Ref: 740_DA5_320_008

RESPONSE TO REFERRAL ENTITY INFORMATION REQUEST LETTER

DEVELOPMENT APPLICATION FOR A MATERIAL CHANGE OF USE – DEVELOPMENT PERMIT FOR EXTRACTIVE INDUSTRY AT THE EXISTING BROMELTON NORTH QUARRY ON LAND SITUATED OFF SANDY CREEK ROAD, BROMELTON, QLD 4285, PROPERLY DESCRIBED AS LOT 1 ON RP98576

OFFICE OF COORDINATOR-GENERAL REF. AP2022/022

Figure 1: Tributaries

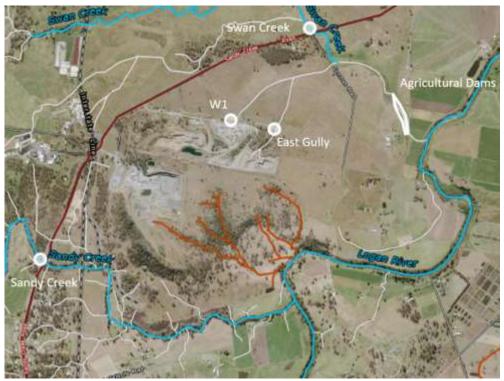
It is considered appropriate that the release limits during large storm events should meet the Water Quality Objectives for drinking water quality outlined in the Environmental Protection (Water and Wetland Biodiversity) Policy 2019 Schedule 1 for the Logan River.

- a. a comprehensive Site-Based Stormwater Management Plan (quality and quantity) that details:
 - i. stormwater management over the proposed stages of development
 - ii. design information and justification of basin sizing (for both existing and new basins) to demonstrate how construction throughout development will be managed to protect drinking water supply Environmental Values and facilitate the Water Quality Objectives for the Logan River basin and achieve compliance with Performance Outcomes PO7 and PO8 of the Seqwater Development Guidelines for both construction and operational phases
 - iii. the number of existing and proposed discharge points as well as release limits
 - iv. achievement of the stormwater management design objectives outlined in the State Planning Policy, Appendix 2, Table B and be prepared by a Registered Professional Engineer of Queensland.

While condition WA1 of the common conditions restricts the release of contaminants to waters, it does not prescribe criteria relating to water quality in the event of a release. Any release from the site will occur on the northern boundary, at either location W1 (the sediment pond), or the East Gully. Releases will enter a large, grassed area, before crossing the unsealed Corcoran Road, entering Swan Creek. Swan Creek flows to a series of constructed dams located within the adjoining property thence the Logan River. Upstream environments from W1 and the East Gully include Swan Creek and Sandy Creek, which both flow to the Logan River (refer **Figure 1**).

A search of the Department of Environment and Science ('DES') *Environmental Protection Act 1994 Public Register* has been carried out to compare discharge conditions for similar operations within the eastern Logan River catchment, with comparable the environmental values and mapped in the lowland freshwater region.

This search identified that the adjacent Bromelton Quarry (EA ref: EPPR00473413) has nominated performance targets as replicated in **Table 1**.

It is acknowledged that the inclusion of release limits, within the EA, would provide Neilsens, DES and the Coordinator-Generals Office with improved clarity with regard to site discharge requirements. An EA Amendment will be made to DES in due course.

A Stormwater Management Plan has been prepared for the site (refer **Attachment 1 – Stormwater Management Plan**). This SMP has identified stormwater quality and quantity management for the ultimate quarry footprint. Given the current extent of extraction area, it is proposed to extend to the maximum disturbance area on commencement under any SDA Approval. For the purposes of the SMP, these performance targets have been adopted with a monitoring frequency of monthly, rather than quarterly.
